**MODEL MD900 SERIES
TECHNICAL BULLETIN PACKAGE**

**THIS PACKAGE CONTAINS A COMPLETE SET OF ALL
MD900 SERIES TECHNICAL BULLETINS ISSUED
THROUGH:**

12 DECEMBER 2022

VSCS ACTUATOR MOUNTING BRACKET REPAIR

Figure 1. Heat/Defog Modification

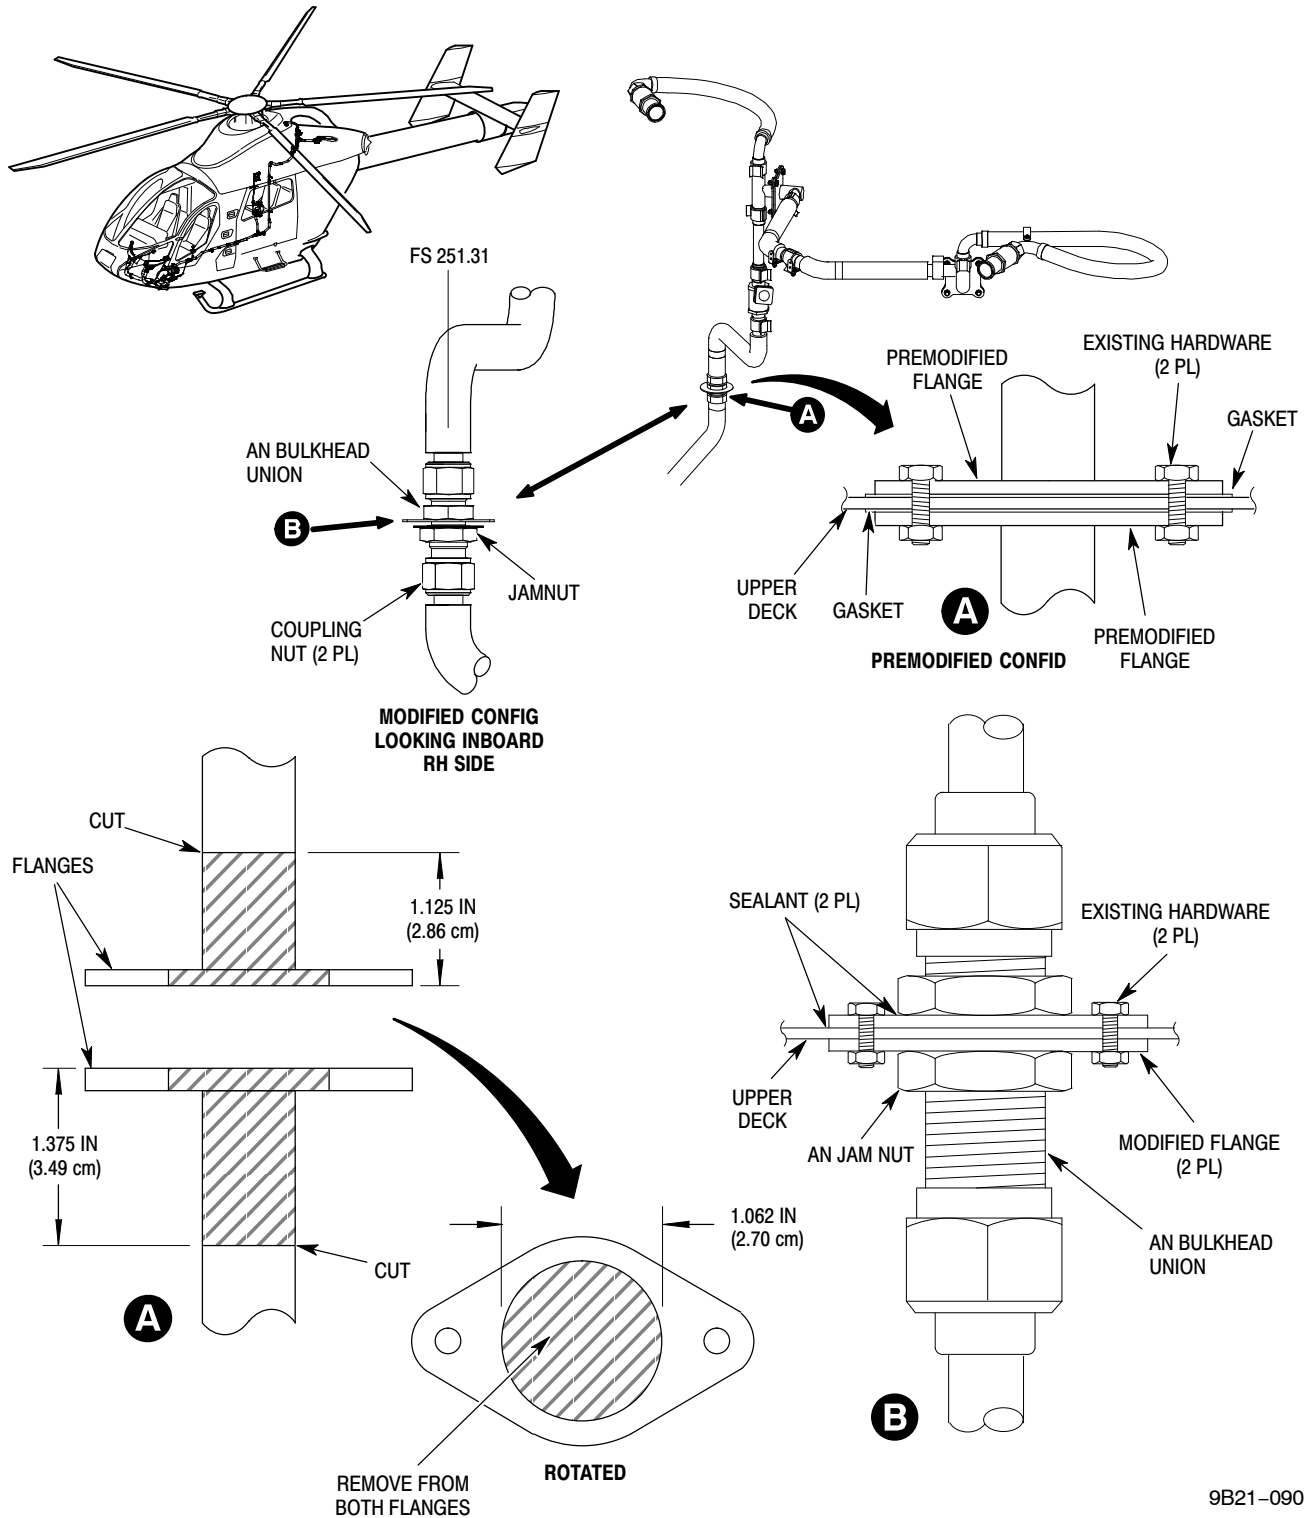
- (13). Reinstall flanges wet with fireproof sealing compound and original hardware. Torque bolts **36-46 in. lb. (4.0-5.2 N•m)**.
- (14). Clean AN bulkhead union and jam nut with Desoclean 45 or equivalent and blow dry with filtered compressed air.

- (15). Install bulkhead union through flanges, coat upper threads with thread locking compound and install jam nut. Torque jam nut **500-600 in. lb. (56.48-67.77 N•m)**.

Figure 1. Location of Cracks in the Roof Rib Installation (Typical, Both Sides)

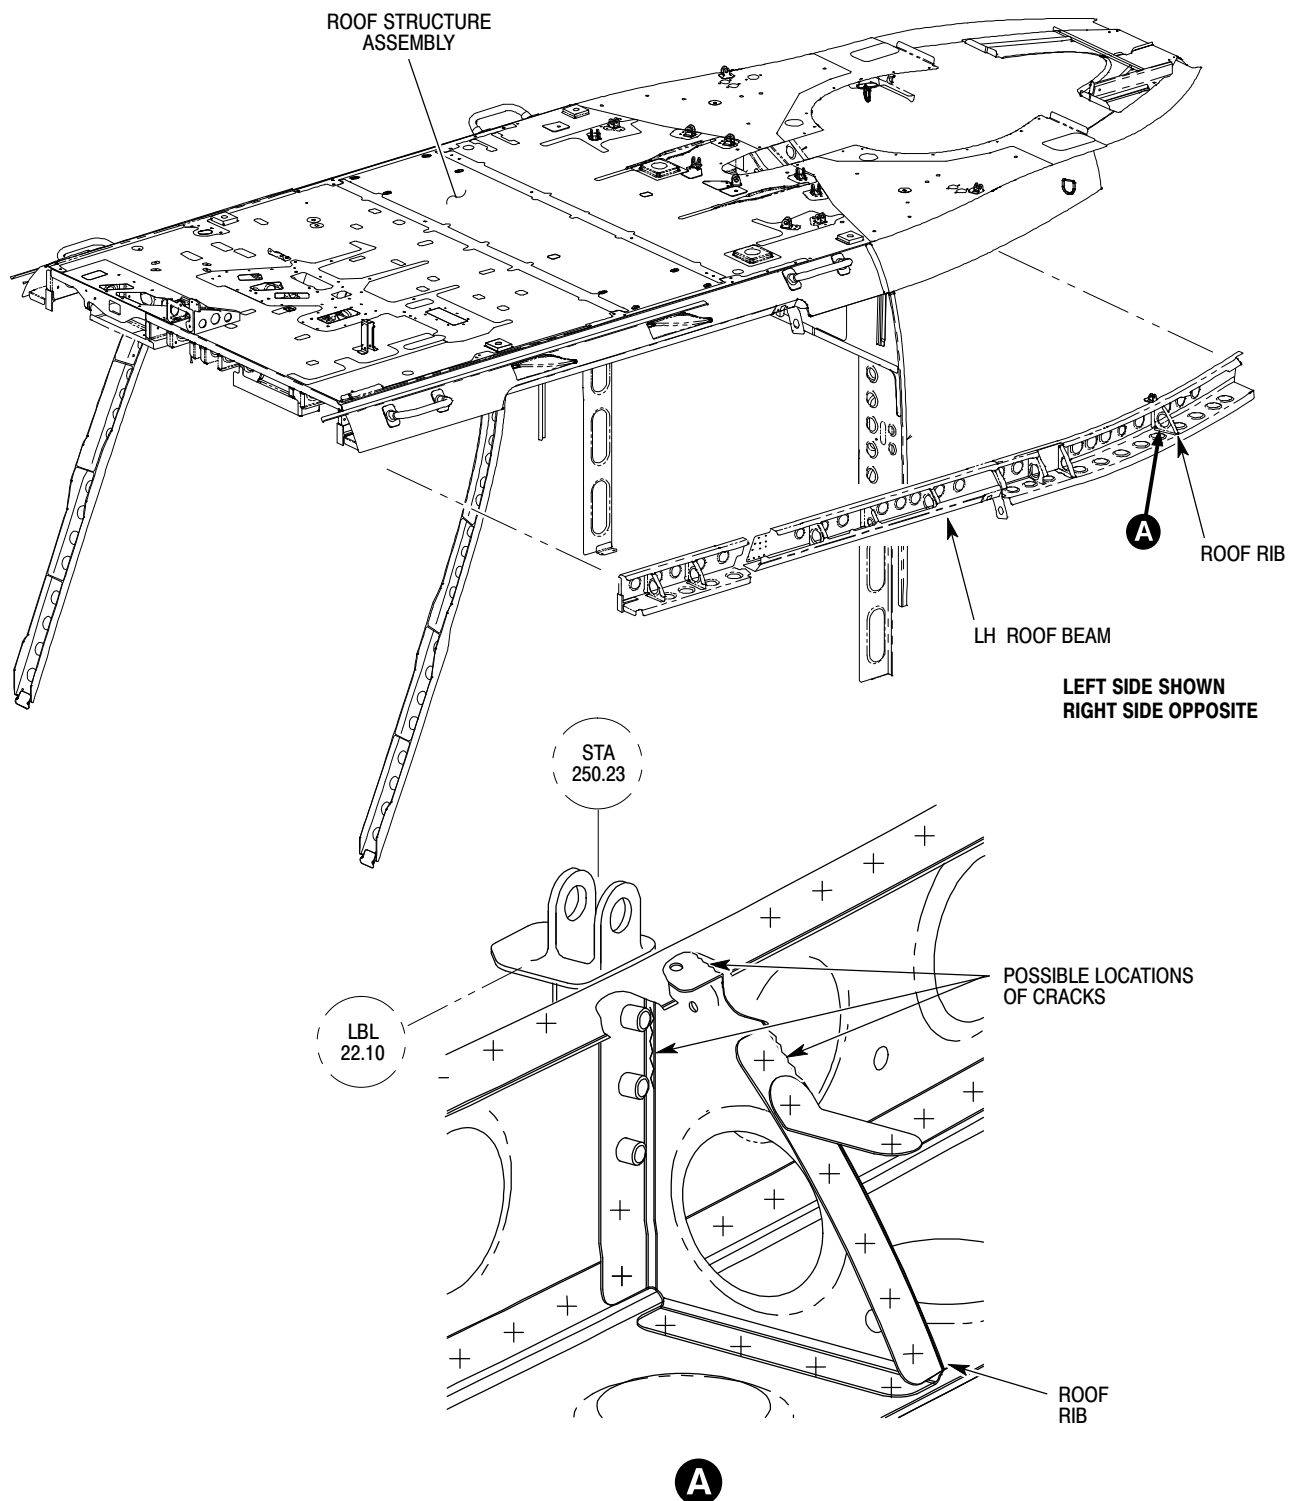
Cracks have been reported in the installed roof beam rib, on the inboard and outboard sides of the ribs and along the top flange of the ribs. The cracks are from **0.25 to 1.50 inch (6.4 to 38.1 mm) long** and are found to begin in the upper bend radius between the inboard flange and the web of the rib (ref. Figure 1).

Figure 3. Make or Modify a Roof Rib

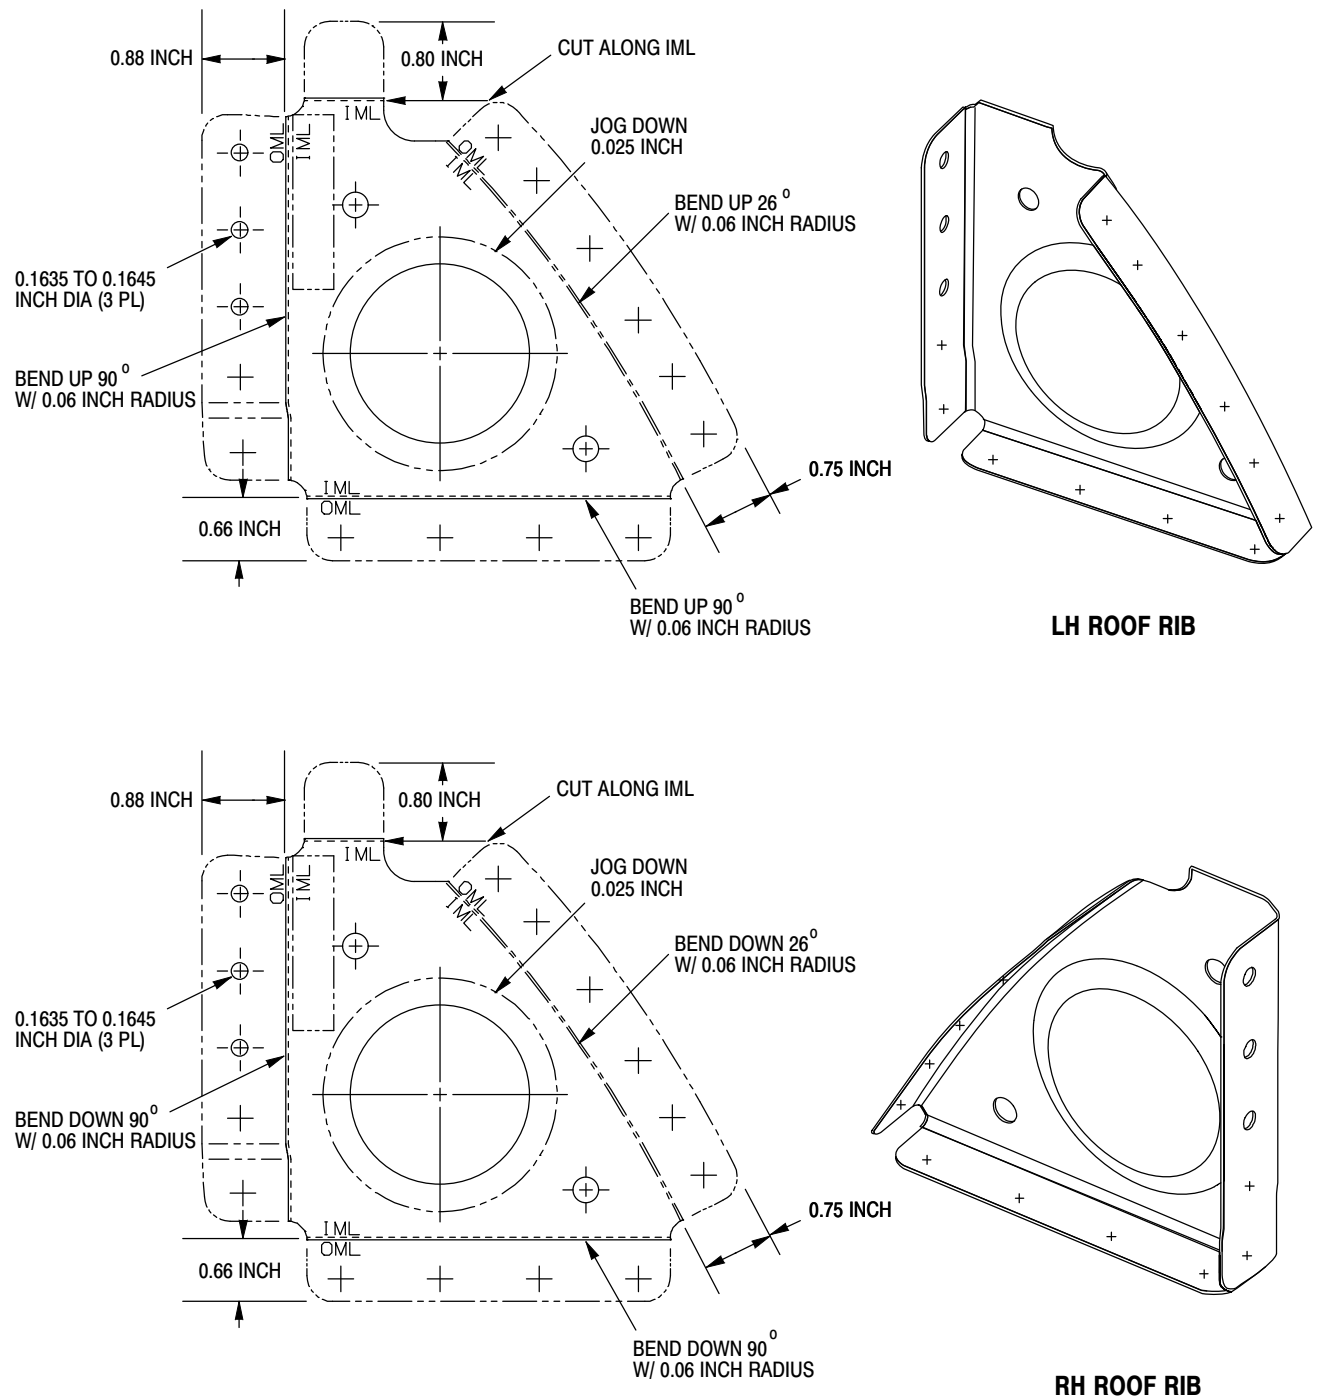
- (a). Use the dimensions in Figure 3.
- (b). Do not drill out the holes.
- (2). Make a cut along the IML to remove the top flange.
- (3). Make two **0.15 inch (3.8 mm)** fillets on each corner of the cut flange.
- (4). Apply corrosion protection to all surfaces. (Ref. CSP-SPM, 20-40-00, Procedure 8.A.)
- (5). Apply primer (C308) to all surfaces. (Ref. CSP-SPM, 20-30-00, Procedure 2.C.)
- (6). Identify the new rib as TB900033-103 (left rib) or TB900033-104 (right rib) with a permanent marker (C829).

Figure 3. Location of 24 Control Bearings

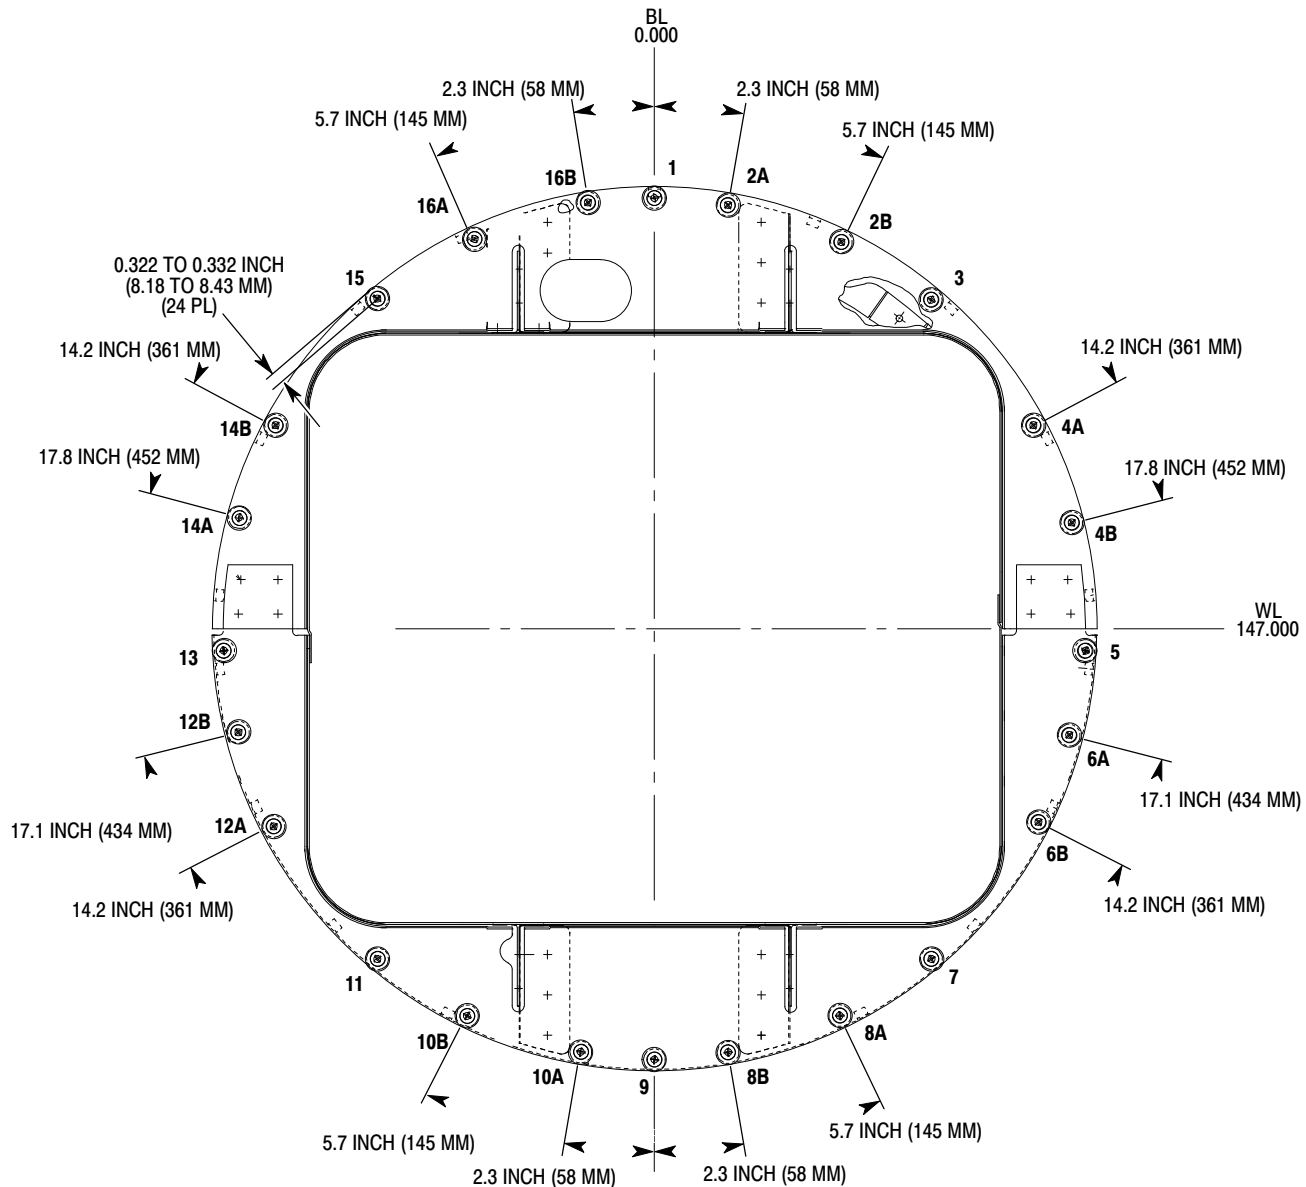
- (z). Deleted.
- (aa). Deleted.
- (4). Find new bolt holes at locations 2A, 2B, 4A, 4B, 6A, 6B, 8A, 8B, 10A, 10B, 12A, 12B, 14A, 14B, 16A, and 16B (ref. Fig. 3) with MD900 stationary thruster bearing hole location tool (PN 900F2421510-107-DJ1), tape measure, and C-clamps. (Ref. Figure 3 and Figure 4.)

Figure 4. Find And Drill New Holes With The Location Tool

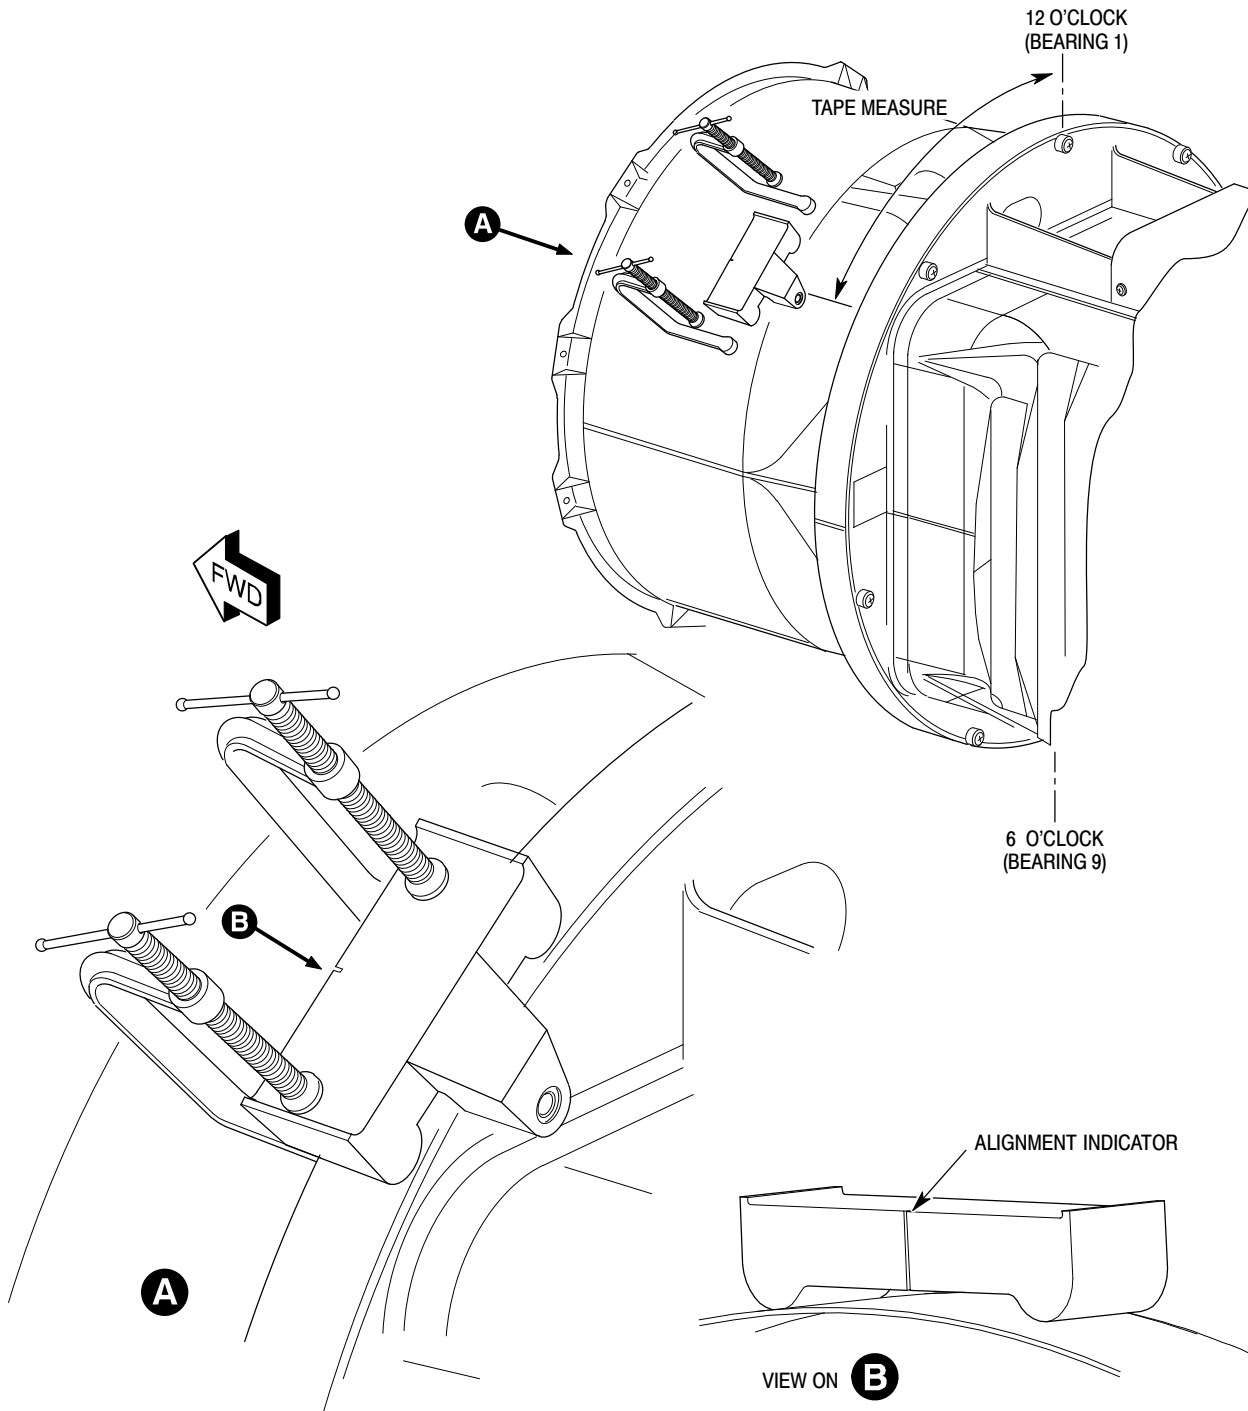
- (5). Drill 16 **0.190 to 0.193 inch (4.83 to 4.90 mm) diameter** bolt holes with MD900 stationary thruster bearing hole location tool (PN 900F2421510-107-DJ1), C-clamps and a spade bit at locations 2A, 2B, 4A, 4B, 6A, 6B, 8A, 8B, 10A, 10B, 12A, 12B, 14A, 14B, 16A, and 16B. (Ref. Figure 4.)

- (a). Deburr the holes.
- (6). Drill 32 holes for the nutplate rivets with a nutplate jig and **0.098 inch (2.5 mm)** or #40 drill with a spade bit.
 - (a). Deburr the holes.
